**Amendments to the Drawings**

Attachment: Replacement Sheet  
Annotated Marked-Up Drawings

Figure 2

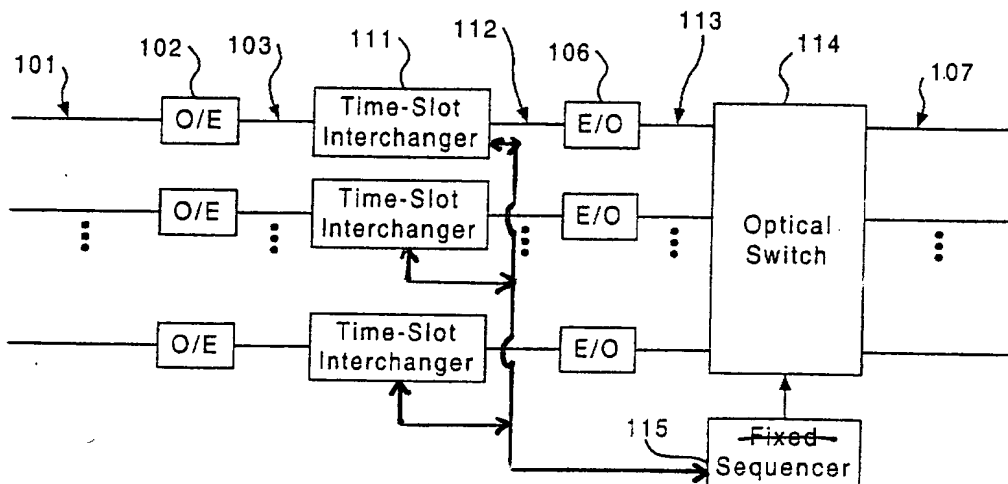
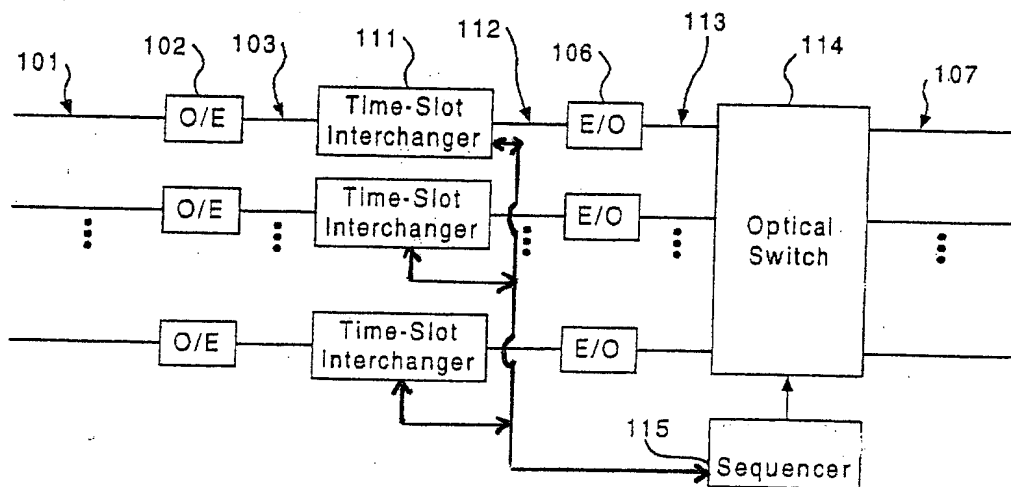
Figs. 2 and 3 have been amended to replace “Fixed Sequencer” with “Sequencer.”

Figs. 2 and 3 have also been amended to include bi-directional arrows between sequencer 115 and the time slot interchangers 111 to illustrate a communication link between the two elements.
